Resource Technologies, Inc.

April 12, 2019

Subject: Work Plan Modification;
Stagecoach Inn; 209 Madison Avenue; West Yellowstone, Montana
Facility ID 16-00464, Release 3358, Workplan 10910

Figure 1
 Proposed Locations
 April 2019
 Stage Coach Inn
 West Yellowstone, Montana

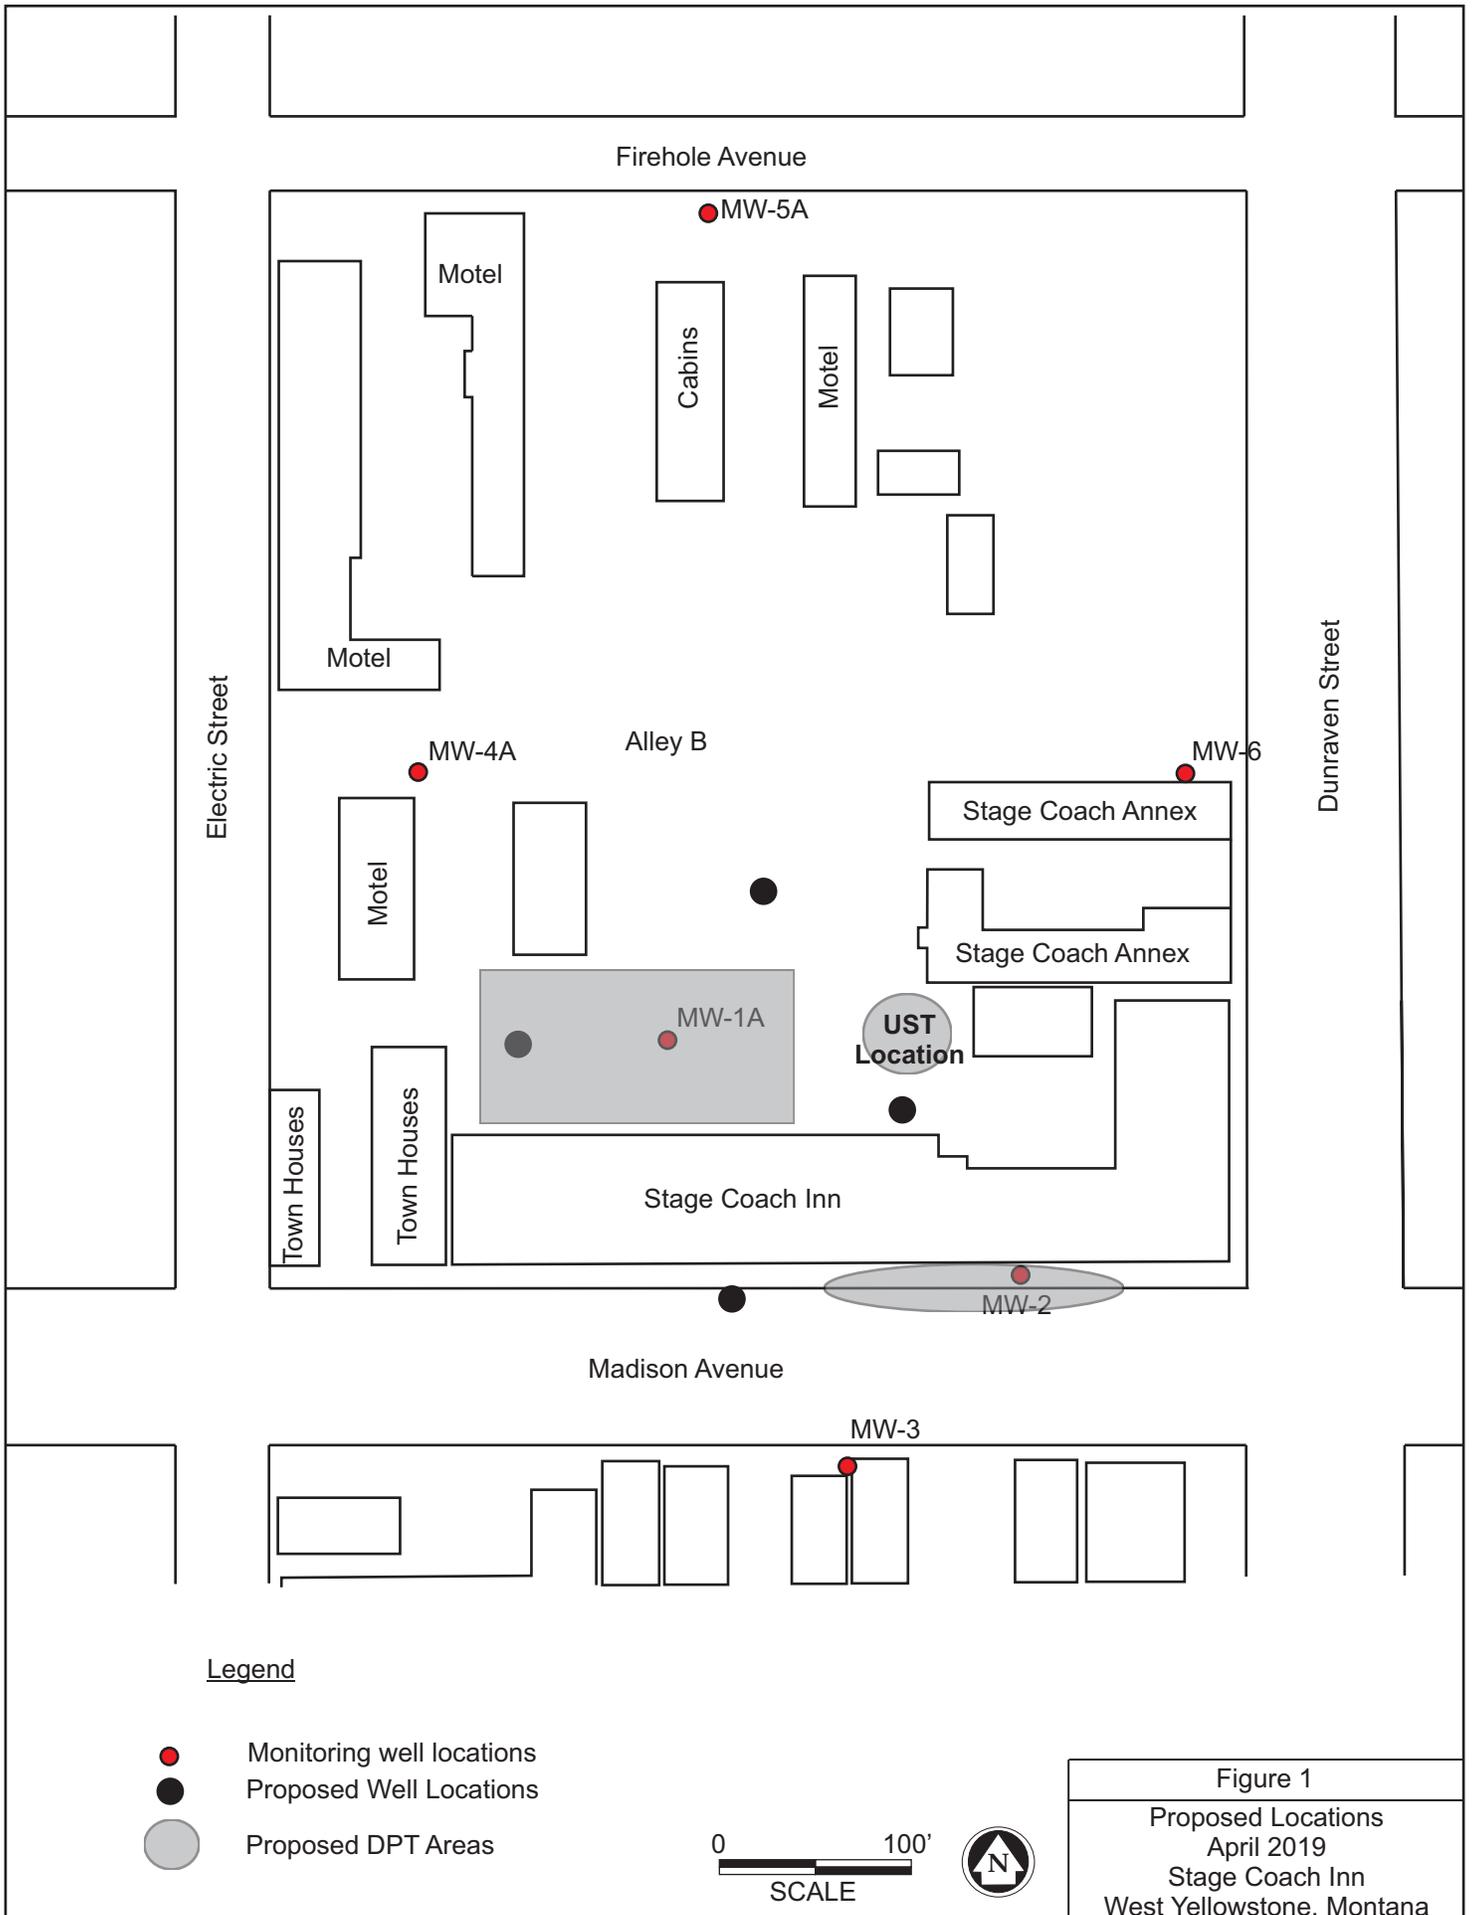
Areas for DPT soil borings are shown on the attached map and include the fuel oil source area south of the building, the former Underground Storage Tank (UST) location west of the Shop building, and the open area extending from the UST basin to the west towards MW-1A. A work zone will be established around the drill rig and support vehicles to reroute traffic and provide pedestrian control.

Proposed Monitoring Well locations are shown on the attached map and include a well west of MW-2, a well north of the building, a well west of MW-1A, and a well north of MW-1A and the UST basin.
